# Service Bulletin

Bulletin No.: RS-79

Subject: BENDIX FUEL INJECTION SYSTEM RSA-10ED2 PARTS LIST 2524791-4  
MODIFICATION TO ISSUE 5

Figure 1. Mixture Control Location

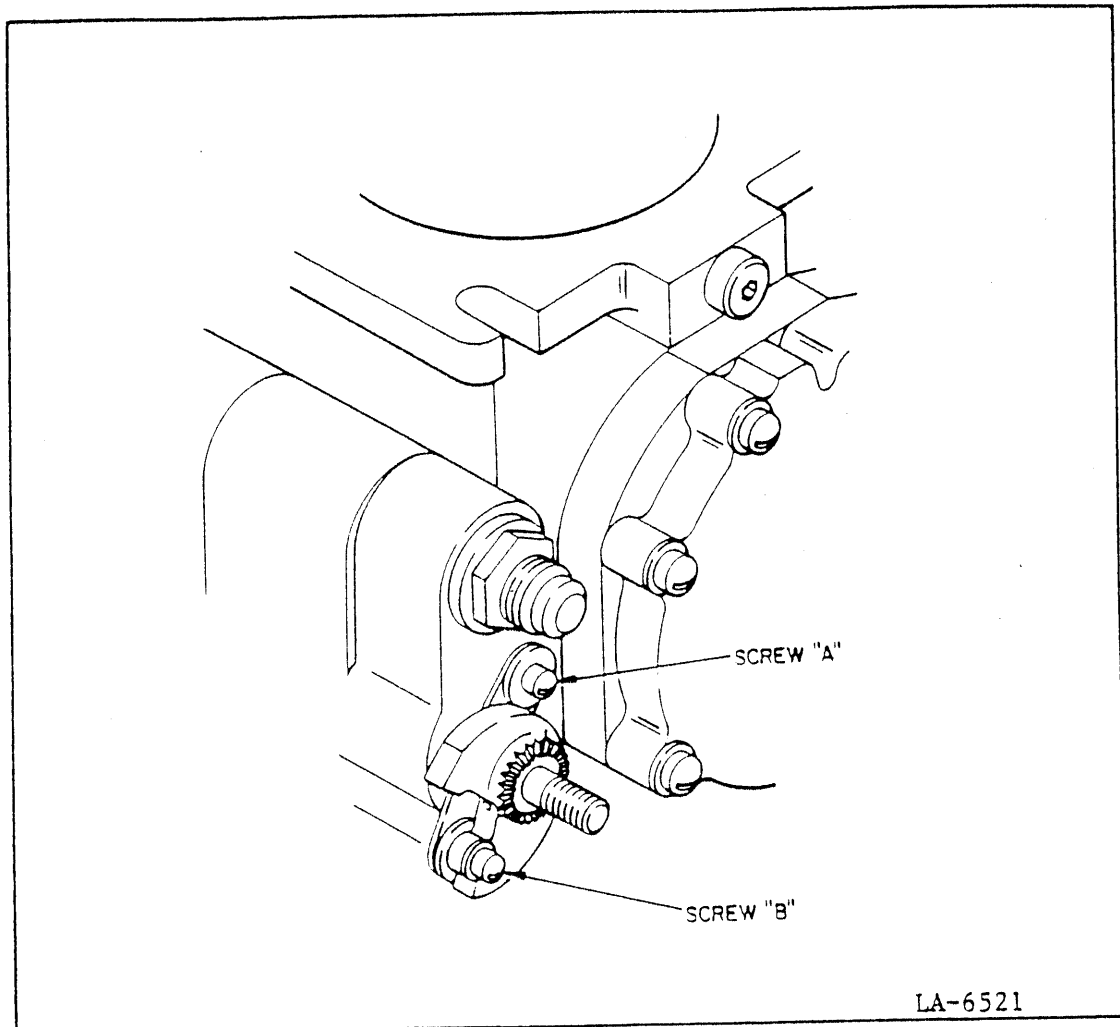
- (1) Remove manual mixture control assembly (Figure 1) from injector housing.
- (2) Remove mixture control plate P/N 2537657 from injector housing and replace with new mixture control plate P/N 2541326.
- (3) Apply a thin film of ASTM No. 5 oil to the back side of the plate which contacts the mixture control valve.

- (4) Replace manual mixture control assembly to injector housing.
- (5) Install washers, spacer, screw "A" and screw "B" to mixture control housing in the exact locations as taken apart. Tighten screw "A" to a torque value of 15-20 pound-inches. Tighten screw "B" to a torque value of 10-12 pound-inches.
- (6) Install new lockwire in same locations as previously installed.
